**Addendum No. 1**

**City of Coquitlam  
Tender 21-042**

**Coquitlam Crunch Parking Lot**

Issue Date: May 28, 2021  
(consists of 4 pages, including Attachment No. 1)

**Drawing 04 - Revision D  
Coquitlam Crunch Parking Lot**

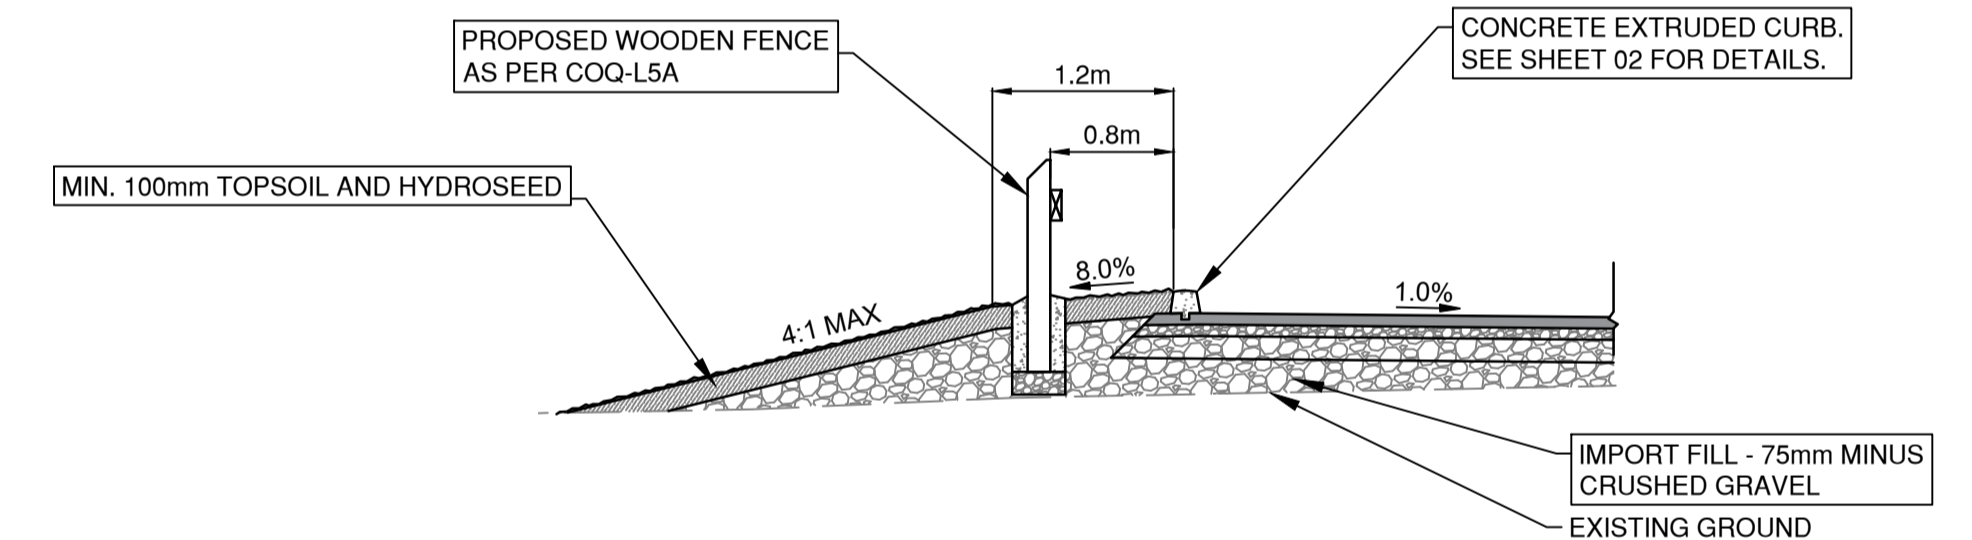
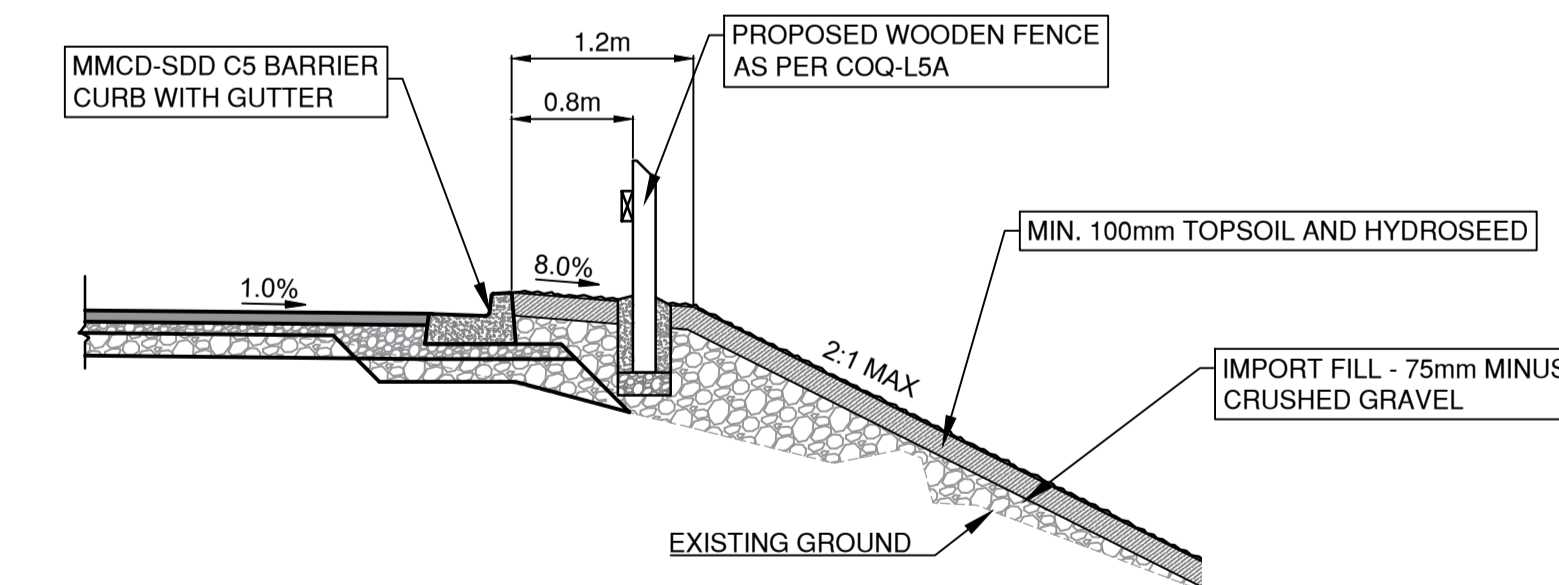
In the Contract Drawings, Drawing 04 - Revision C – Coquitlam Crunch Parking Lot

**is deleted and replaced with:**

Drawing 04 - Revision D - Coquitlam Crunch Parking Lot – included as Attachment No. 1 to this Addendum No. 1

Q1 Is it possible to get an existing topographic site plan for the work areas? Can the proposed grades be shown on the plan?

**A1 Existing topographic site information can be found on Drawing 4 – Revision D - Coquitlam Crunch Parking Lot included as Attachment No. 1 to this Addendum No. 1. This contains additional proposed spot elevations in the parking lot.**
